**Re: NER S5.2.5.10 Guideline Consultation**

# Schedule 1

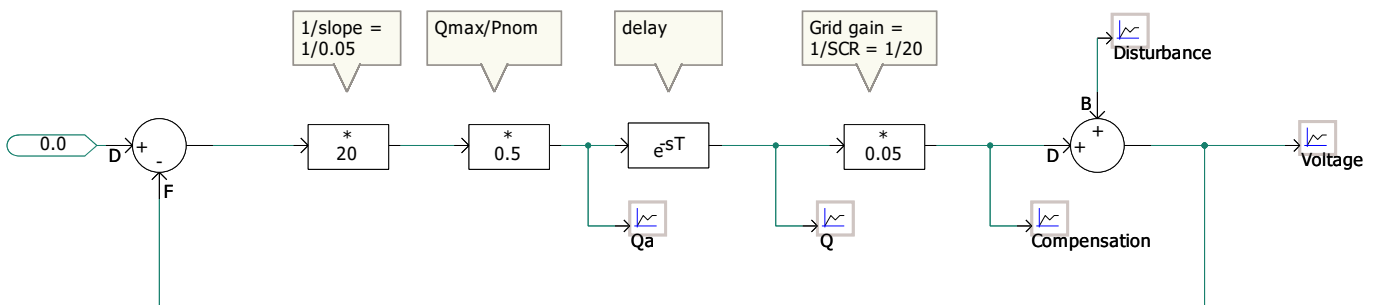
As per Figure 1 in AEMO’s Technical Note, Equations 3 to 5 are not conclusive since a close-loop voltage control system is described. Therefore, the relationship between disturbance and controlled voltage should be defined as:

In addition, it is implied from  $C = K * Q$  equation that K is considered as the grid gain relating reactive power to voltage compensation. However, the gain of G includes both the voltage droop gain as well as the grid gain.

The angle  $\theta$  in Equation 5 is defined as the angle between disturbance D and compensation C. However, this angle does not have practical meaning, since in reality only the angle between voltage V and compensation C can be measured.

$$V = \frac{1}{1 + G} \times D \text{ or } H = \frac{V}{D} = \frac{1}{1 + G}$$

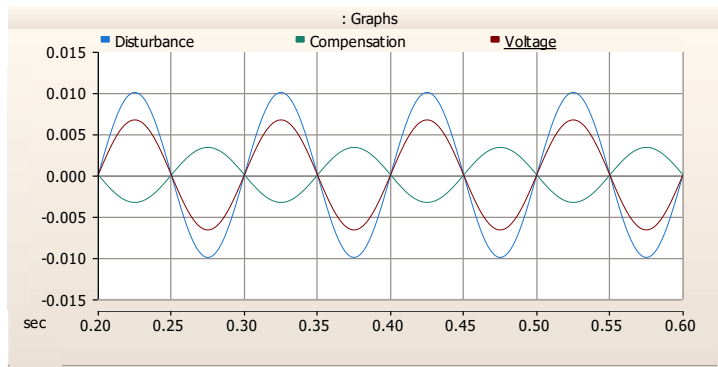
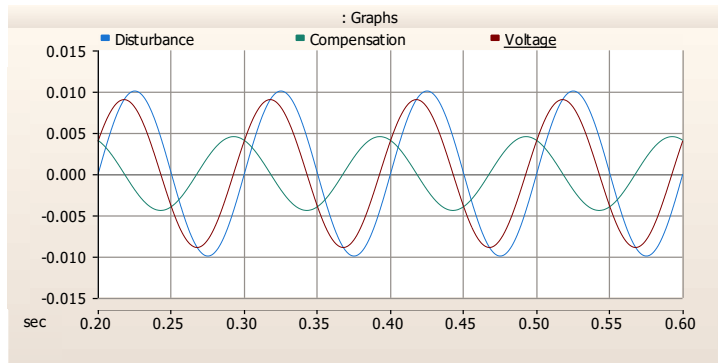
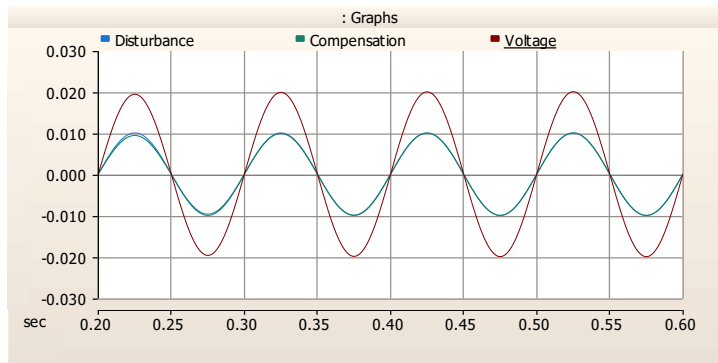
As an example, a simplified voltage control system of a wind power plant is displayed in the figure below.

It is important to note that the above system performance can be investigated based on the angle which is defined between Voltage and Compensation (and not between Disturbance and Compensation).

In the above example, the gain G would be  $|G| = \left(\frac{1}{0.05}\right) \times 0.5 \times \left(\frac{1}{20}\right) = 0.5$ , while the disturbance has a magnitude of  $A = 0.01$ .
